SUBJECT: ISSUANCE OF AMENDMENT NO. 49 TO FACILITY OPERATING LICENSE
NO. R-28 UNIVERSITY OF MICHIGAN FORD NUCLEAR REACTOR
(TAC NO. MD1670)

AMENDMENT TO FACILITY OPERATING LICENSE

Amendment No. 49
License No. R-28

SAFETY EVALUATION BY THE OFFICE OF NUCLEAR REACTOR REGULATION

Figure 6.1 Organization Chart for the Ford Nuclear Reactor

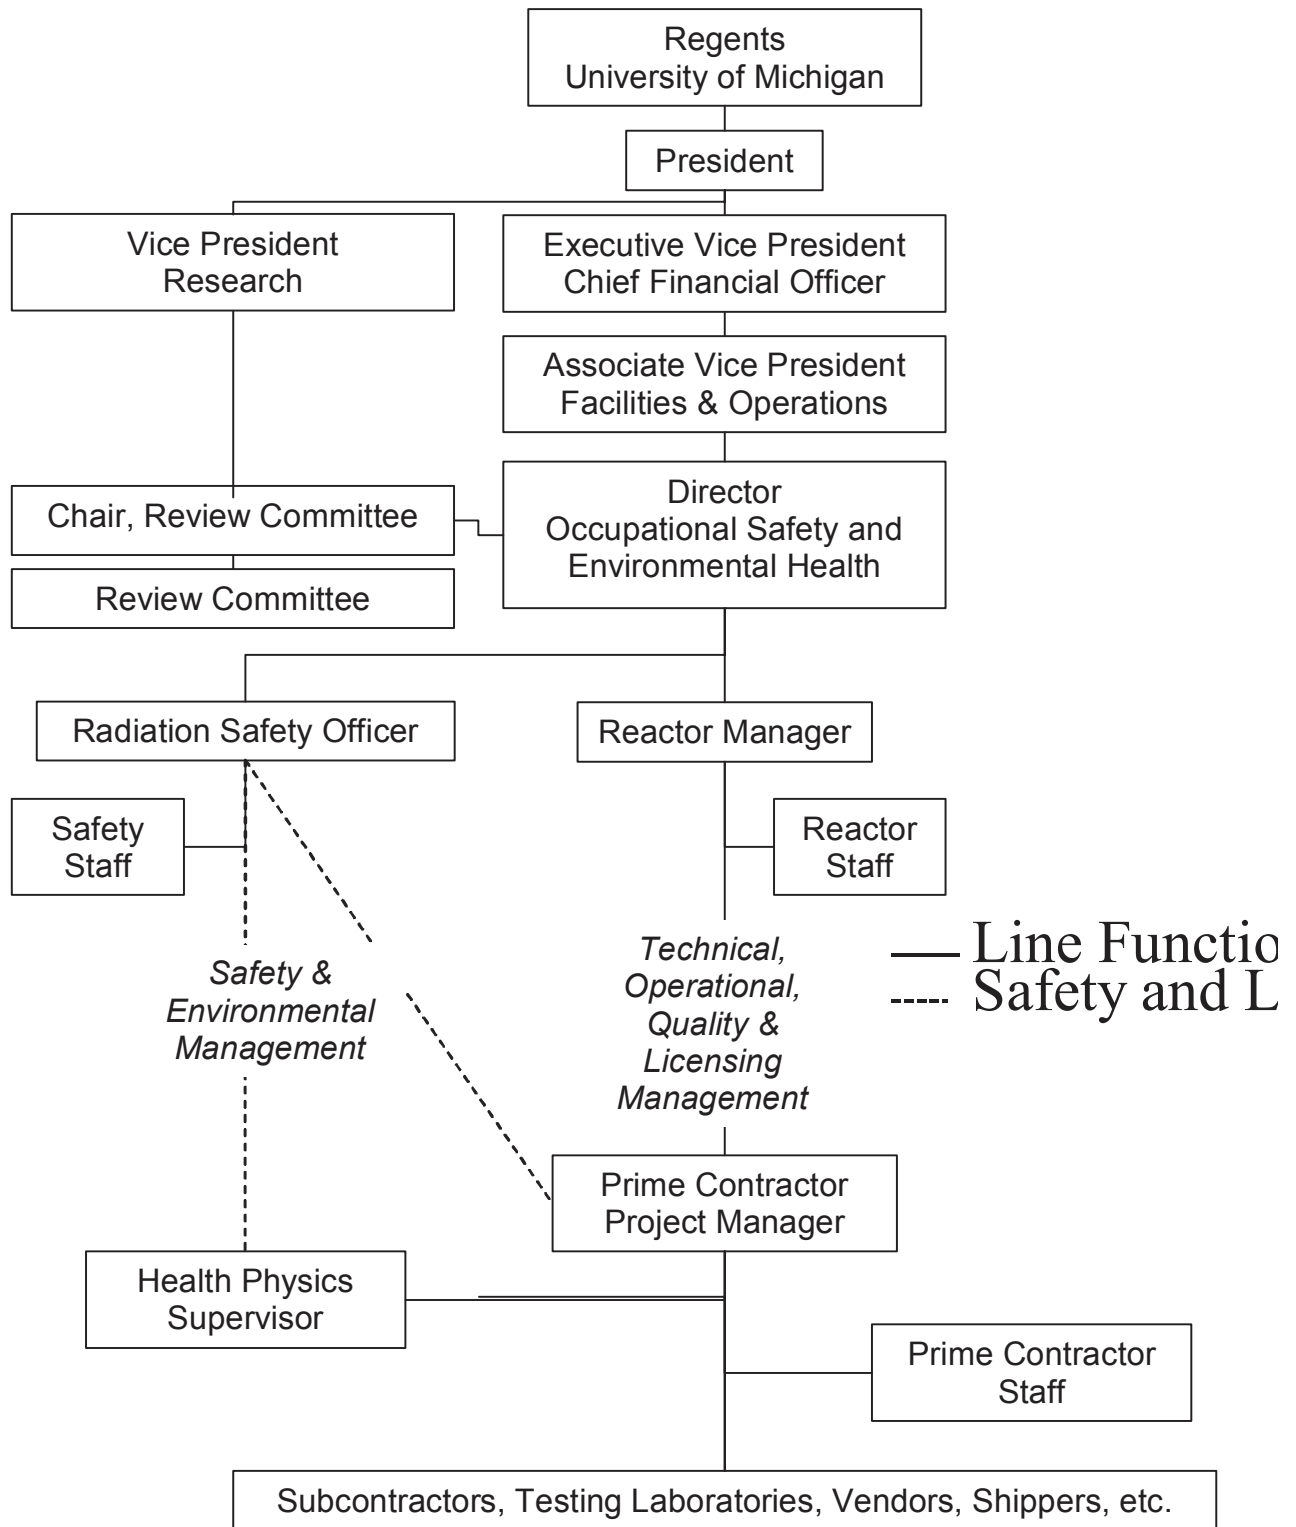
1. The organizational structure of the University of Michigan relating to the Ford Nuclear Reactor (FNR) shall be as shown in Figure 6.1.
2. The Reactor Manager shall be responsible for the safe decommissioning of the Ford Nuclear Reactor. He shall be responsible for assuring that all activities are conducted in a safe manner within the limits prescribed by the facility license, including the technical specifications and facility procedures. During periods of his absence, the responsibilities of the Reactor Manager may be delegated to an individual who satisfies the qualification requirements for the Reactor Manager. *

For the years of licensed activities at FNR, the Director of Michigan Memorial Phoenix Project (MMPP) was responsible for the facility's operating license. The Regents of UM are responsible for overall planning, managing, and financing the decommissioning of the FNR. The bylaws of the Board of Regents specifically assign responsibility for the decommissioning to the Executive Vice President and Chief Financial Officer. The Executive Vice President has established, through the Associate Vice President for Facilities and Operation, a project organization to oversee the decommissioning of FNR. The licensee has proposed changing TS 6.1, Organization, to reflect a new organizational chart for the FNR decommissioning project which includes the following key management positions:

- The Director of Occupational Safety and Environmental Health, who will be responsible for the facility's license and shall authorize the expenditure of funds on decommissioning activities.

- The Reactor Manager who remains responsible for decommissioning FNR and assuring that all activities are conducted in a safe manner within the limitations of the facility's license and in compliance with applicable federal and state regulations.

- The Radiation Safety Officer (RSO), who is organizationally independent of the Reactor Manager, his support staff or any decommissioning contractors or sub-contractors, shall be responsible for radiological safety at the facility, and safeguarding the UM community, the public, and personnel involved in decommissioning from undue radiation exposures.

- A review committee, chaired by a representative of the Vice President for Research, will monitor decommissioning activities to ensure they are being performed safely, economically, and according to all applicable licenses or registrations held by the UM and in compliance with applicable federal and state regulatory requirements.

- A prime contractor to manage and supervise all or part of the FNR decommissioning project. The prime contractor will manage and supervise operations and services such as characterization, dismantlement, decontamination, waste handling, and quality assurance.
